Submissions Report

Build-to-Rent Housing

46-52 Nicholson Street and 59-67 Christie Street, St Leonards

SSD-88113706

Figure 4 Setback Study – Over 25m - Levels 6-7
Source: Cox Architecture

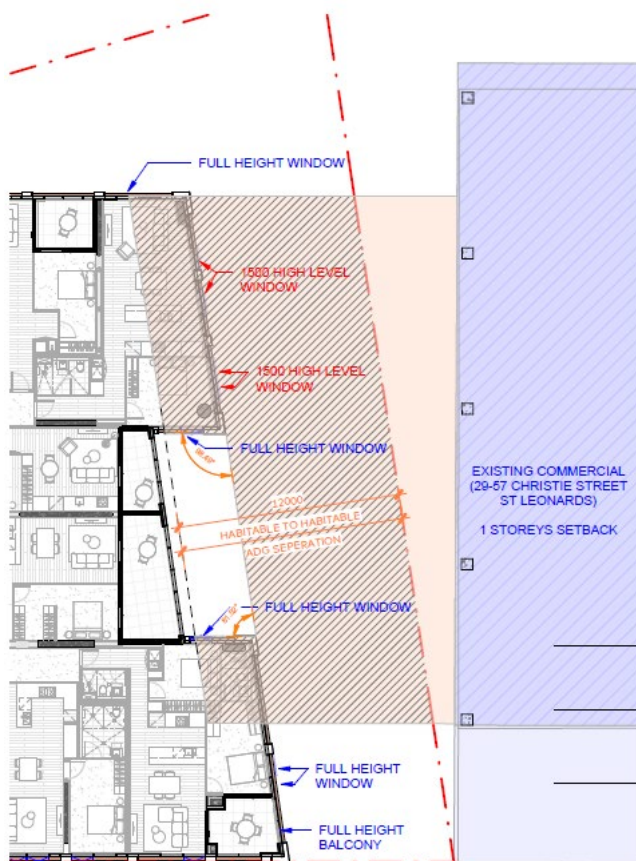
Issue/ Comment	Response
	 Figure 24: Viewpoint locations - 88 Christie Street Source: Colliers
<u>Building Setbacks and Privacy (29-57 Christie Street)</u> c) The proposed 9m tower setback to 29 -57 Christie Street is expected to result in privacy, solar, and ventilation impacts that contribute to reducing amenity for both sites. In accordance with the ADG, setbacks should be designed to mitigate direct overlooking, maintain adequate solar access, and support natural ventilation. Provide a revised scheme that achieves recommended ADG setbacks and includes an analysis demonstrating how privacy impacts have been mitigated. Consider angled or high-level glazing (where there is a choice of more than one window) that can direct views away from the adjoining property, privacy screens, landscape screening, and built in landscape planters.	As noted in Section 3.2.2, the proposal only provides a building setback below the ADG recommendation on Levels 6-22. The approved concept envelope for 29-57 Christie Street has a maximum height of RL 151.4 which is at a similar height to Level 22 (floor level at RL 149.1) of the proposed building. On Levels 6-22, the proposed building provides a southern setback of 9m-12m with a separation distance of 9.1m to 14.7m between both proposed buildings. The proposal has been amended to incorporate 1.5m high windows on the southern façade on Levels 6-22 to minimise potential opportunities for overlooking to the future development at 29-57 Christie Street. The proposal is compliant with the ADG building separation requirements on Levels 3-7 and Level 23 to Roof Level. Further, this concept DA has been approved for five years since July 2021 and no detailed DA has been lodged to date. Therefore, there is no certainty that this would be developed in the future. While the Concept DA approves an envelope, it is typically not expected that an envelope would be fully maximised in any case. Refer to Section 3.2.2 and Design Report Addendum for further details on privacy measures implemented at the interfaces of the updated proposal and the proposed tower at 29-57 Christie Street.

- Angled windows have also been added to the bedroom windows in the middle portion and to the windows on the west and east elevations to limit the sightlines of these rooms.

- As the south western interface of proposed building does not face the proposed tower of the neighbouring site, full height windows have been retained for this interface.

- Similarly, full height windows have been retained for the middle part of the south elevation which has a 13m setback.

Figure 14 Updated Lower Ground Plan

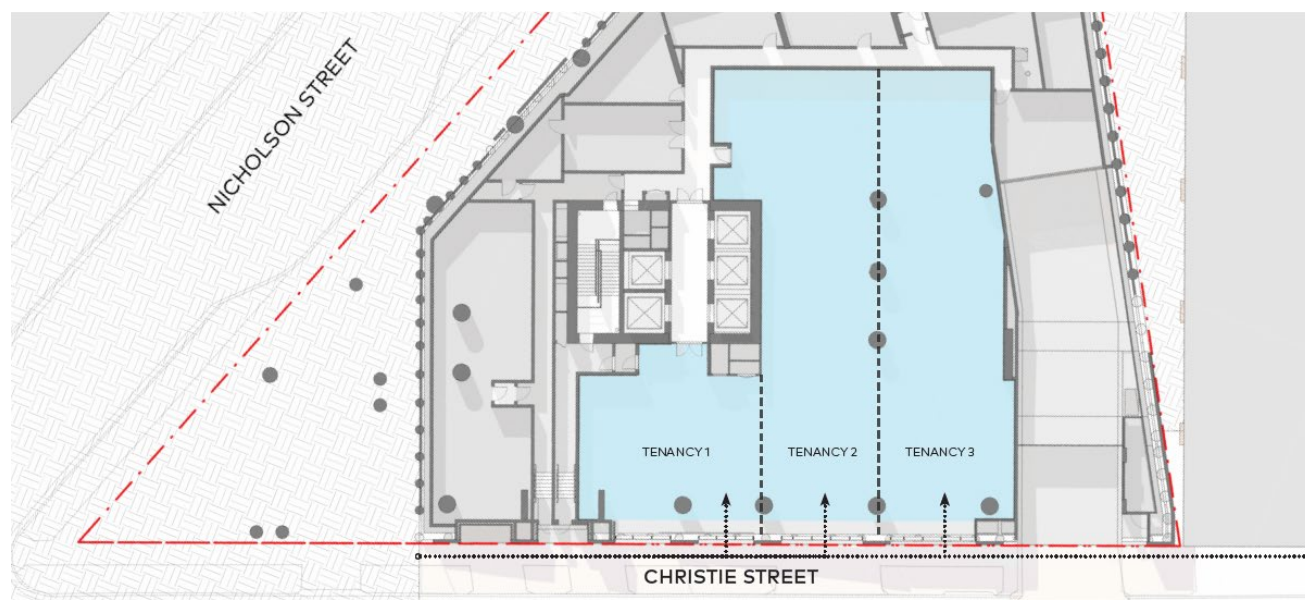
2. Active Use	
Chapter 3, Part 4 of the Housing SEPP requires the street of a BTR development in a business zone to have an active frontage. The proposed pool facilities along the Christie Street frontage creates a closed-off, exclusive use that does not activate the street. No justification has been provided for limiting opportunities for active tenancies along this frontage. The site is zoned E2 Commercial Centre under the <i>Lane Cove Local Environmental Plan 2009</i> (LCLEP 2009), which seeks diverse, active street frontages that attract pedestrians and contribute to vibrant public spaces. The site also forms part of the St Leonards commercial core under the Crows Nest Precinct Design Guide, where development is expected to maintain a balance of commercial and residential uses. The proposal is inconsistent with these objectives. The Department does not support the proposal in its current form as it fails to provide an active ground-floor interface with the public domain. Provide revised plans that include commercial or publicly accessible active uses, particularly along the Christie Street frontage.	As noted in Section 3.2.4, the updated proposal has amended the Lower Ground floor plan to provide commercial tenancies at street level. The street level façade on Christie Street has been amended to provide glazing and pedestrian entries, which will enable passive surveillance and an active street frontage. The updated proposal therefore complies with the active street frontage requirement in Section 76 of the Housing SEPP and the objectives of the E2 zone under LCLEP 2009 relating to the provision of active street frontages and strengthening the role of the commercial centre.

The Lower Ground Floor Plan has been amended to provide commercial use fronting Christie Street.

Pedestrian entries have been added to the Christie Street frontage. Glazing will be provided on the Christie Street frontage to facilitate passive surveillance and an active street frontage.

The floorplate on lower ground floor is capable of being subdivided into three tenancies in the future, subject to separate planning approval.

Figure 15 Proposed bike parking in Basement 1
Source: Cox Architecture

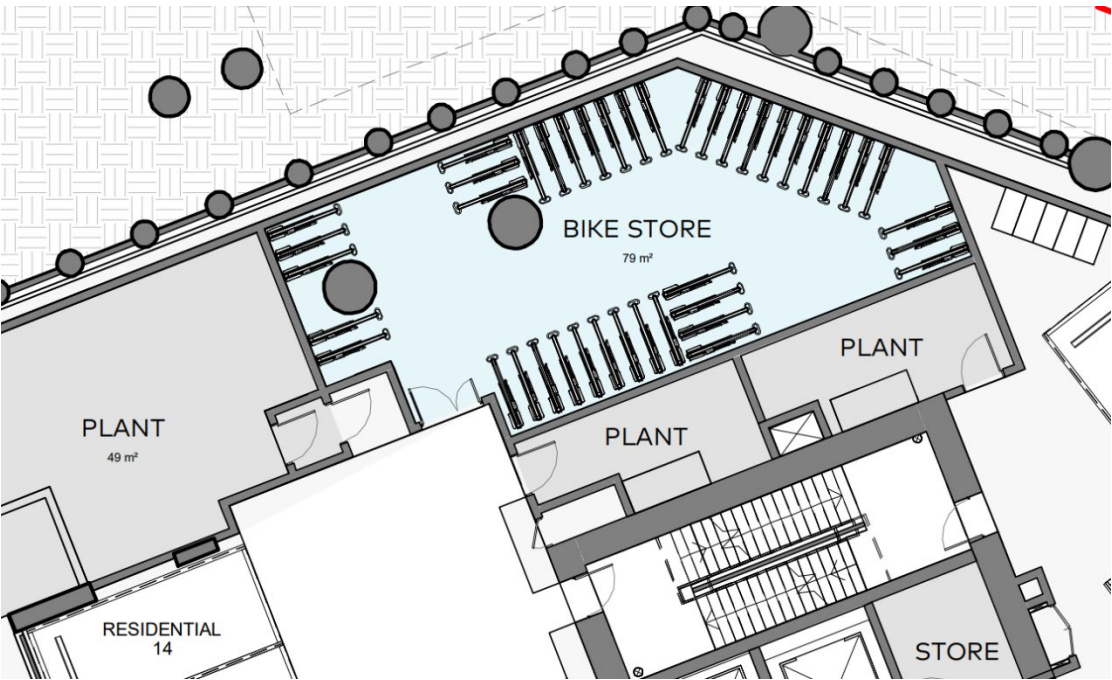
• Insufficient carparking, which does not comply with the non-discretionary standard in the Housing SEPP • Lack of visitor parking. The proposal will put significant strain on the limited on-street parking. • Shortfall in bicycle parking • EV charging stations to be shown on the plans	TfNSW Council Public
	<i>Engineering and Servicing</i>	DPHI

The provision of bicycle parking has been increased from 78 spaces to 82 spaces. In addition, the layout of the 42 (50% of) city starter apartments has also been reconfigured to include bicycle storage within the unit.

This result in the provision of a total of 124 spaces for bicycle parking / storage, which is an increase of 46 spaces compared to SSDA submission.

Figure 18 Amendment to building roof form
Source: Cox Architecture

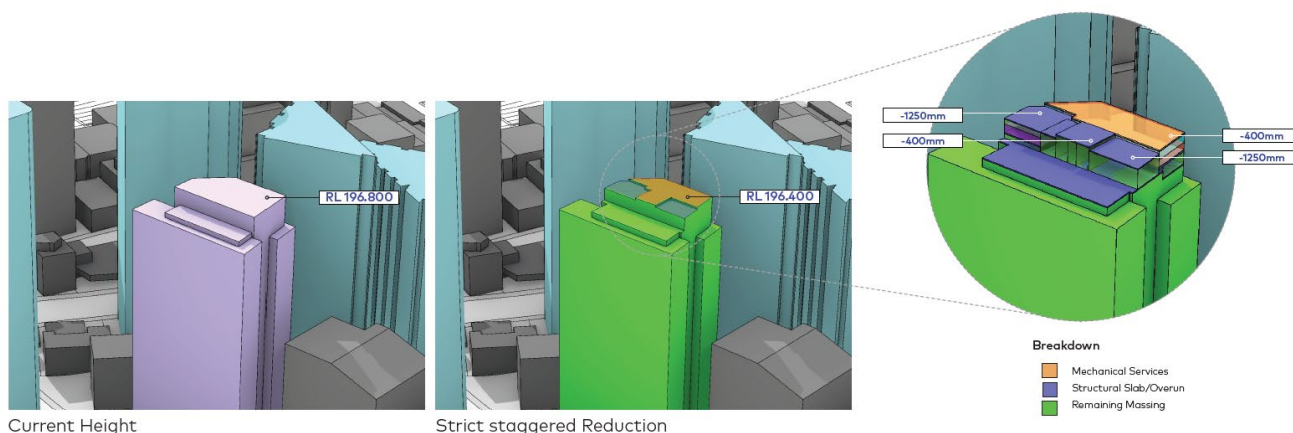
3. Built Form	
<u>Building Height and View Loss</u> a) The Department considers it important to balance the provision of housing with the amenity of the locality, while being mindful of impacts on surrounding development. The proposed height increase under the planning proposal and visual impact will result in severe view loss of iconic landmarks from existing and	The View and Visual Impact Assessment Addendum (VVIA Addendum), prepared by Colliers and attached as Appendix M, provides further justification on the visual and view loss impact to the residential developments of Telstra Exchange BTR, The Landmark, and St Leonards Square. In summary:

The roof form of the proposed building has been amended to provide a staggered form, resulting in a reduction in building height by 400mm to 1,250mm, to a maximum height of RL 196.4.

As identified in the View and Visual Impact Assessment Addendum (**Appendix M**), the staggered reduction in building form results in improvements to views from the upper levels of St Leonards Square, The Landmark and Telstra Exchange, with increased portions of building silhouettes within the Sydney CBD and sky visible.

Figure 23 Level 33-34 - Awning

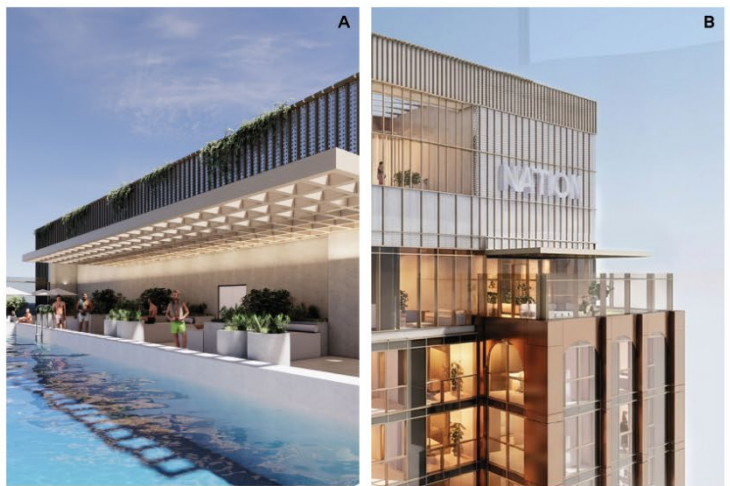
• Provide a wind tunnel program and update the wind assessment documents to demonstrate how the single aspect apartments can achieve cross ventilation • Existing wind conditions on Nicholson Street and St Leonards Square Plaza	
	Flooding Impacts	DPHI

In response to the recommendations of the updated Pedestrian Wind Environment Study and wind tunnelling program (**Appendix I**) prepared by Windtech.

Figure 25 Typical EV distribution board
Source: Colliers

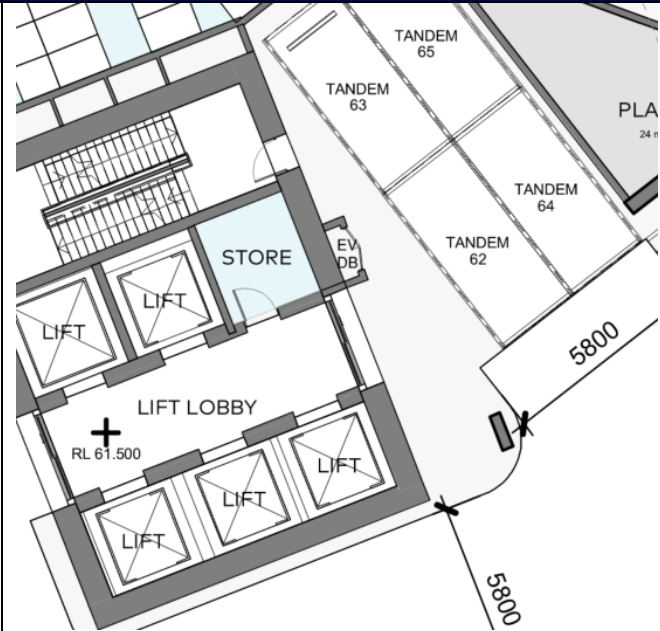
g) The Ecologically Sustainable Development (ESD) report indicates that all car parking spaces will have EV charging provisions with additional consideration for e-bike charging. The Department supports this initiative and requests that EV charging stations be shown on the plans.	The NCC J9D4 mandates that car parks associated with new Class 2 buildings be future-proofed to support future charging demands. The proposal includes the required charging infrastructure to accommodate future charging requirements in the form of distribution boards on each basement level and cable trays to each parking space.

Figure 5: View impact from Landmark Tower. Approved concept SSD envelope = bronze dashed line.
(Source: Ethos Urban)

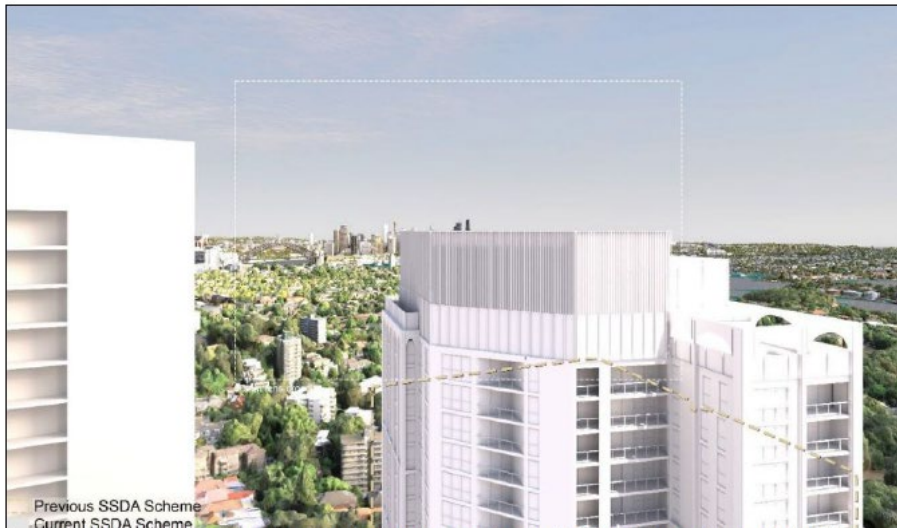
Issue/ Comment	Proponent Response
1. Height Increase <i>The approved Planning Proposal and Concept SSD permitted an envelope of 31 storeys and RL of 174.95. The approved height is considered an appropriate height transition between the tower developments on the Pacific Highway, and the lower properties south of the site (including the part 18, 12 and 8-storey commercial development at 29-57 Christie Street).</i> <i>The proposed height increases to approximately 36-storeys and RL of 196.8 is more suitable for a tower building fronting the Pacific Highway. The subject site is located 1 block south from the Pacific Highway interface and should reflect a reduced envelope. The additional height proposed is contrary to the envisioned built form and transitional character.</i> <i>Council does not support the increase in height by 21.85m and 5-storey's + lift over run. The proposal would be inconsistent with the approved Planning Proposal and approved SSD Concept Design. The increase of height would be an overdevelopment of the site and would dominate the urban form.</i>	The proposed height increase is appropriate because: • It is in response to the NSW Government's commitment to meeting housing targets under the National Housing Accord following years of strategic focus on the St Leonards Strategic Centre. • It is consistent with the HDA's recommendation and Minister's declaration to deliver high-yield housing on site. • The proposal is consistent with the relevant State, Regional and District planning strategies for St Leonards, including the St Leonards and Crows Nest 2036 Plan and vision and intent of the Crows Nest Accelerated TOD precinct. • The proposed height will facilitate much needed and sought-after diversity of housing product proximate to public transport in the form of 541 BTR dwellings and contribution towards affordable housing. The development will provide significant public domain improvements, enhancing pedestrian connectivity between St Leonards train station and Crows Nest Metro station, encouraging use of the public transport infrastructure. It has been demonstrated that in the Concurrent Rezoning Proposal submitted that the proposal has strategic and site-specific merits. • Potential environmental impacts associated with the building height, including view sharing, visual impact and overshadowing have been adequately addressed in this Submissions Report, VVIA Addendum, Architectural Plans and Design Report Addendum. • Ultimately, the proposal seeks to capitalise on the proximity to the St Leonards and Crows Nest Metro stations and provide a high quality and residential amenity focused BTR development.
